Form 3160-5
(June 2019)UNITED STATES
DEPARTMENT OF THE INTERIOR
BUREAU OF LAND MANAGEMENTFORM APPROVED
OMB No. 1004-0137
Expires: October 31, 2021**SUNDRY NOTICES AND REPORTS ON WELLS**
Do not use this form for proposals to drill or to re-enter an
abandoned well. Use Form 3160-3 (APD) for such proposals.

8. Well Name and No. KEYSTONE 6 FED COM/702H

EOG respectfully requests an amendment to our approved APD for this well to reflect the following changes:

Revised Permit Information 03/09/2023:

WELL LOCATION AND ACREAGE DEDICATION PLAT

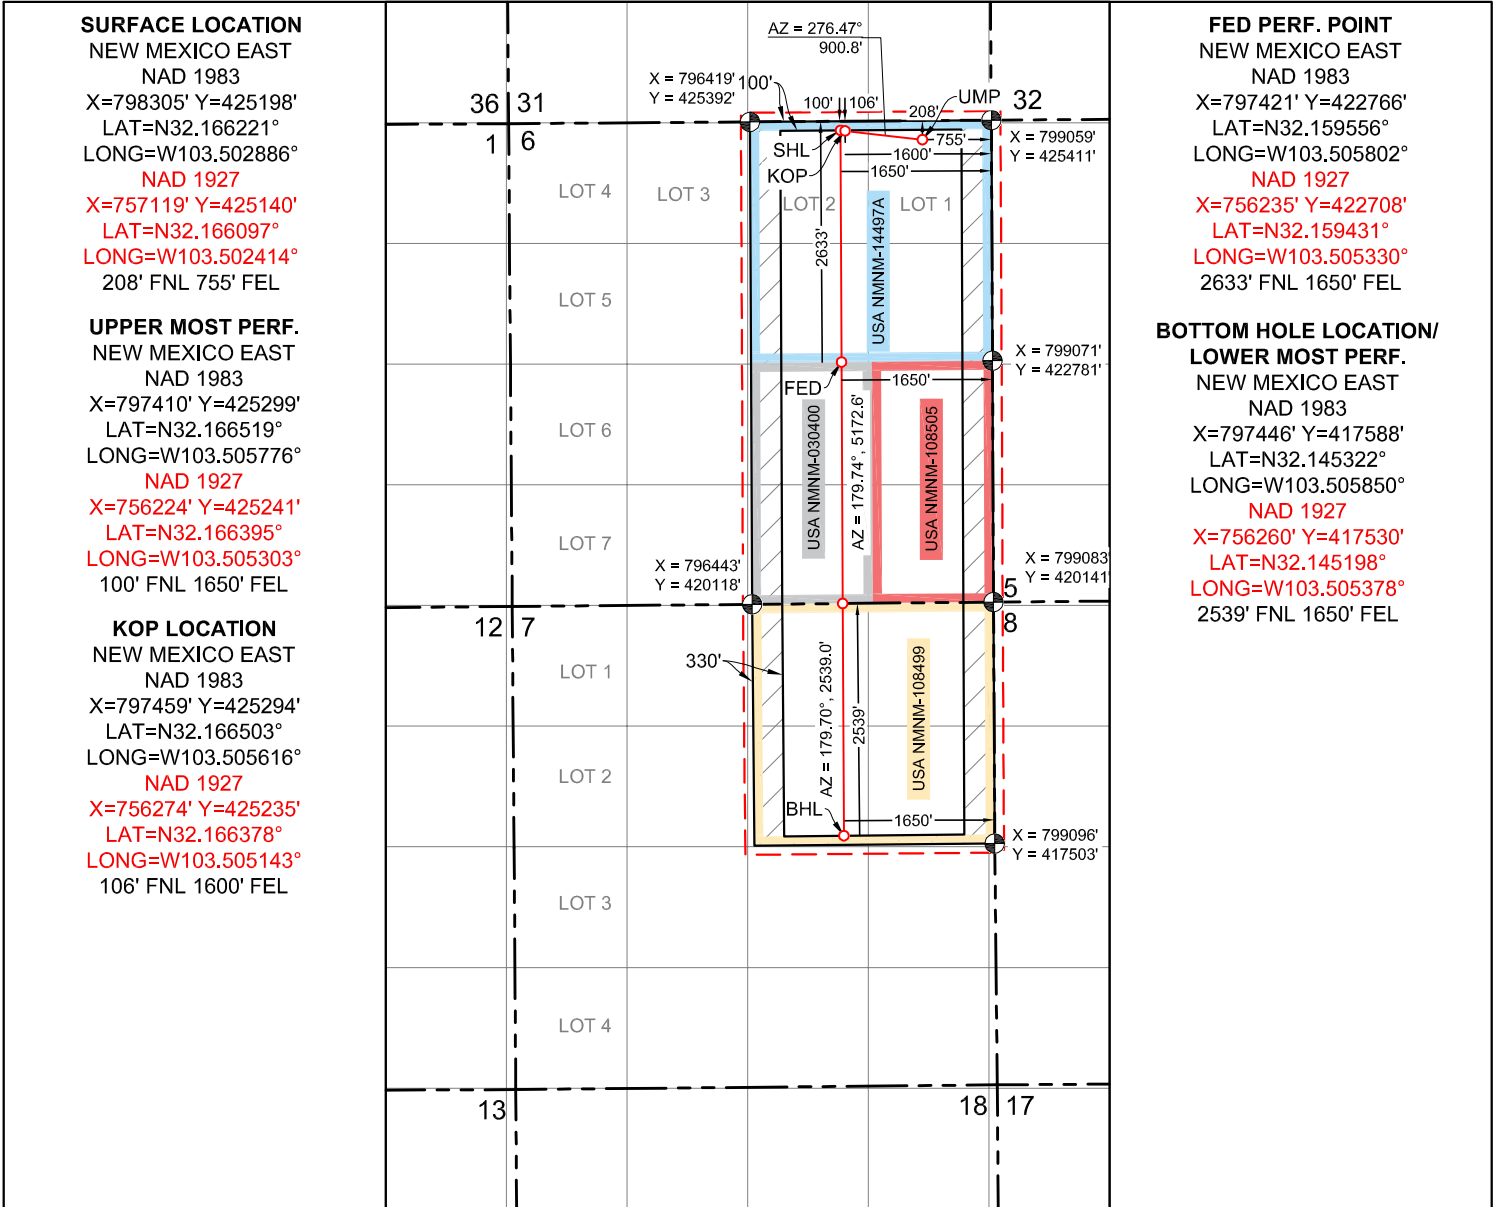
Change BHL from T-25-S, R-34-E, Sec 7, 2539' FNL, 750' FEL, Lea Co., NM,
to T-25-S, R-34-E, Sec 7, 2539' FNL, 1650' FEL, Lea Co., N.M.

UL or lot no. G	Section 7	Township 25 S	Range 34 E	Lot Idn	Feet from the 2539	North/South line NORTH	Feet from the 1650	East/West line EAST	County LEA
--------------------	--------------	------------------	---------------	---------	-----------------------	---------------------------	-----------------------	------------------------	---------------
